REGIONAL TRANSIT ISSUE PAPER

Subject: Approving and Filing the CEQA Addendum for the South Sacramento Corridor Phase 2 Project

Addendum

69 kV Transmission Line Realignment and Multi-Use Bridge & Pathway Lighting

Figure 1-2. Comparison of Approved SMUD Alignment and Proposed Realignment

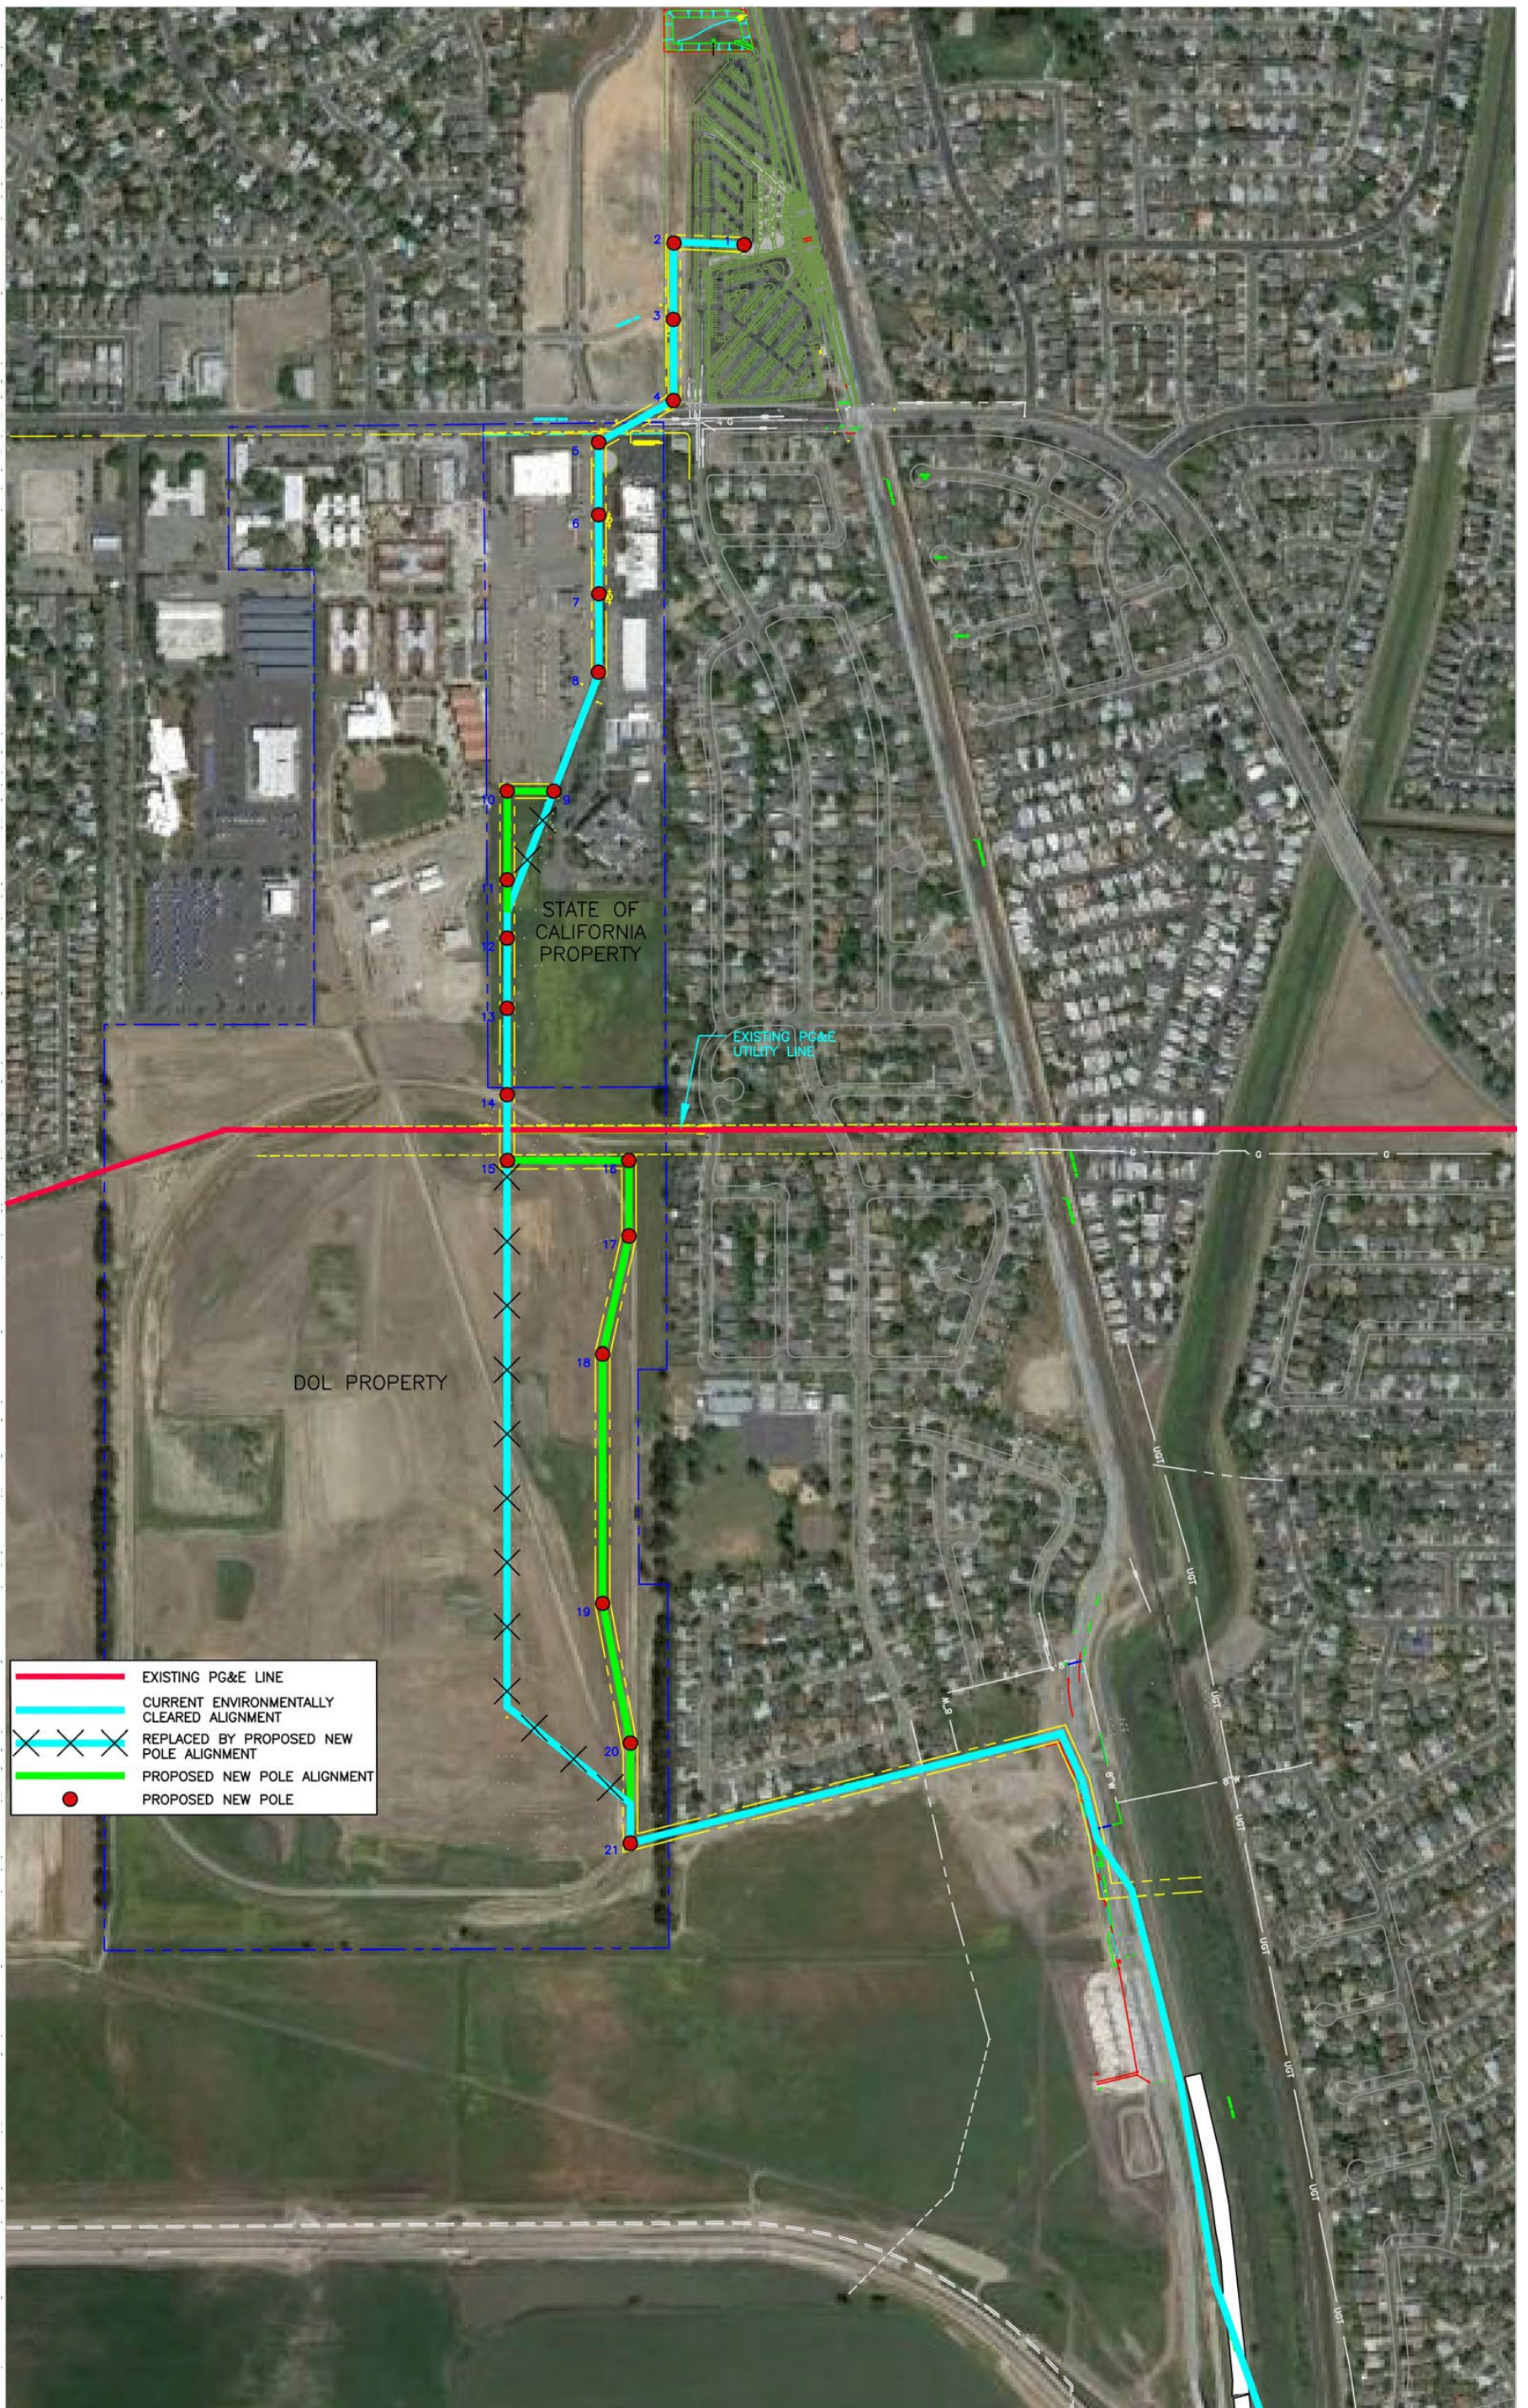
- Pole 9 would be relocated approximately 150 feet southwest of the previously approved alignment easement, and poles 10 and 11 would be rerouted approximately 150 to 200 feet to the west of the approved alignment, so that the utility easement coincides with the CDFA property line. Pole 12 would be relocated to accommodate the realignment.

- Poles 16 through 21 would be rerouted approximately 300 to 450 feet east of the approved alignment, while maintaining a minimum distance of 100 feet west of properties in the Detroit Boulevard neighborhood, within the DOL property boundary.
- An approximately 860-foot swing span would occur from pole 18 to pole 19, in order to avoid sensitive vernal pool wetland resources. This would replace the 740-foot segment swing span alignment from tubular steel poles (TSPs) 16 to 17 described in the 2013 IS/MND.
- Pole 21 would be relocated approximately 130 feet south, adjacent to the oval track on the DOL property.

RT has discussed and reviewed the 69 kV realignment with SMUD, CDFA, DOL, and the Sacramento Job Corps, to ensure that all stakeholders agree the proposed realignment is feasible and would serve the objectives of each agency. The proposed modifications to the 69 kV utility alignment would involve the relocation of poles 9, 10, and 11 on the CDFA property, as well as the relocation of poles 16-21 on the DOL property. Figure 1-3a and Figure 1-3b illustrate the proposed realignment. Realignment modifications are outlined below; no other poles would be affected.

- ▶ An approximately 860-foot swing span would occur from pole 18 to pole 19, in order to avoid sensitive vernal pool wetland resources. This would replace the 740-foot segment swing span alignment from tubular steel poles (TSPs) 16 to 17 described in the 2013 IS/MND.

As described in the 2013 IS/MND, a utility easement would be provided to SMUD as part of the 69 kV realignment, to accommodate both the horizontal sway of conductors from side to side during windy conditions and to accommodate the access road. A standard easement extending 25 feet to either side of the centerline of the 69 kV alignment (50 feet total) would be provided along the bulk of the alignment. A 90-foot-wide easement would be provided between poles 18 and 19 to account for the longer span (Figure 1-2).

Figure 1-4. Pathway Lighting Overview Map

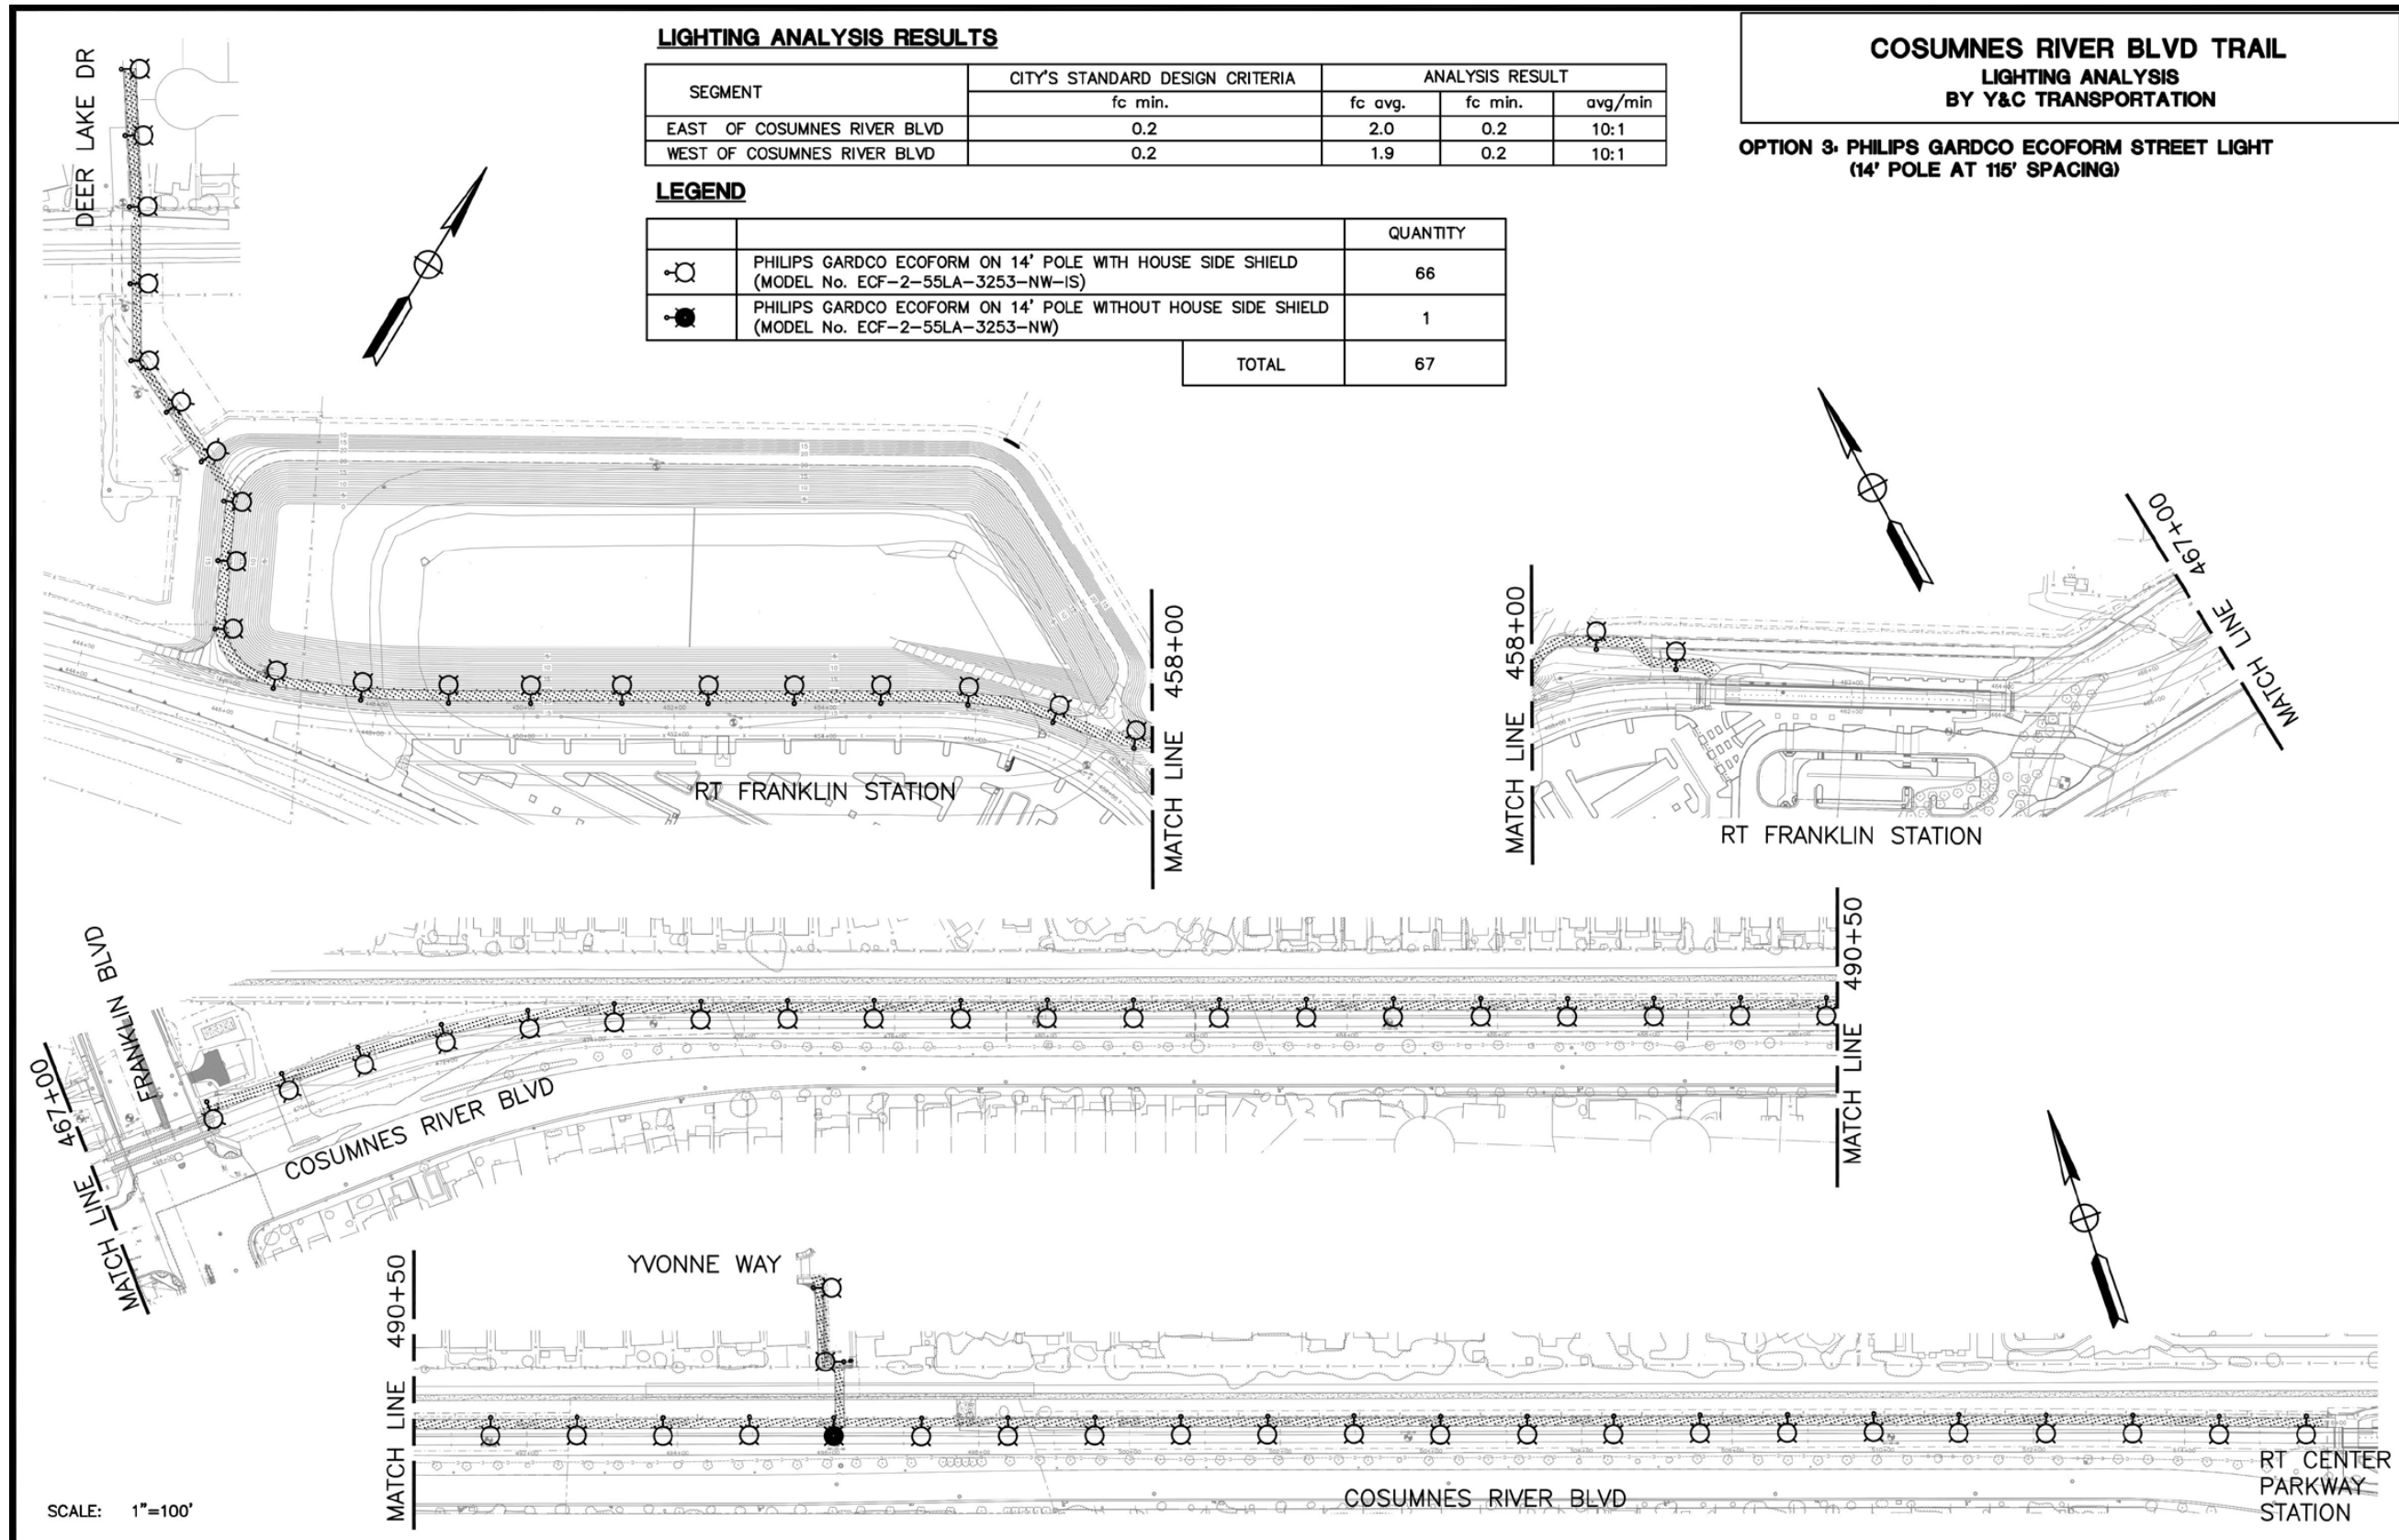
RT proposes to install and operate lighting along the multi-use pathway and bridges (pathway lighting) at the following locations along the existing multi-use pathway that runs north of and adjacent to the LRT (Figure 1-4):

The pathway lighting street lamps would be installed along the north side of the multi-use pathway between Center Parkway and Franklin Boulevard, and on the south side of the multi-use pathway west of the Franklin light rail station. The pathway lighting would project illumination downward onto the pathway. The lighting would use a motion response type luminaire, or fixture, such as the EcoForm lighting by Philips. When no motion is detected, the illumination dims to 10 percent of the desired level to conserve energy. When motion is detected, the illumination would return to the desired level of 2 foot-candles for pathway lighting. The street lamps would consist of three types – 14-foot-tall freestanding lamp posts installed at the edge of the pedestrian/bike pathway, 14-foot-tall freestanding lamp posts installed adjacent to the fence line at the edge of the pedestrian/bike pathway, and 14-foot-tall and 16-foot-tall lamp posts mounted to existing structures along the edge of the pedestrian/bike pathway. Access to the lighting for installation and maintenance would occur from within the RT ROW.

Figure 1-4 summarizes the illumination that would occur with the proposed light fixtures. As shown, the greatest intensity of lighting occurs in the immediate vicinity of the fixture where lighting would average 2 foot-candles; the highest illumination of 5 to 6 foot-candles would occur directly beneath the light fixtures, which is typical for sidewalks. Based on the proposed pole heights and fixture design (including proposed “cut off characteristics”) light spillover would be limited, with illumination reaching near zero foot-candles within 15 feet of the fixtures in a north-south direction (within the RT right-of-way) and within 22.5 feet of the fixtures in an east-west direction (along the pathway). The extent of the illumination, before reaching zero foot-candles, would be slightly greater at the bridges where lighting may extend about 30 to 40 feet from the fixtures.

amount of light that could “spillover” onto areas other than the pathway. All light fixtures, except the one at the Valley Green Pedestrian Bridge, would be fitted with this equipment to lessen light impacts. Figure 1-4 shows the location of the light fixtures and summarizes information about the extent of illumination. In particular, contours around the fixtures show that the greatest intensity is directly below the fixtures, as expected, and that within 15 feet in a north-south direction (towards the residences) and within 22.5 feet in an east-south direction (along the pathway), the illumination would have dimmed to existing ambient conditions. The extent of illumination would be slightly greater at the bridges; however, this would be desirable for safety and the intensity would be typical for suburban settings. Additionally, the lights would use motion response controls to automatically dim during periods of low use. Although approximately 67 light fixtures would be introduced to the project area, the light would be less intense than typical street lights in the neighborhood, and would be designed to focus lighting down onto the pathway. Therefore, the proposed modifications evaluated in this Addendum would not result in a change to the conclusions contained in the 2008 SFEIS/SFEIR, the 2011 IS/EA, or the 2013 IS/MND with respect to aesthetics.
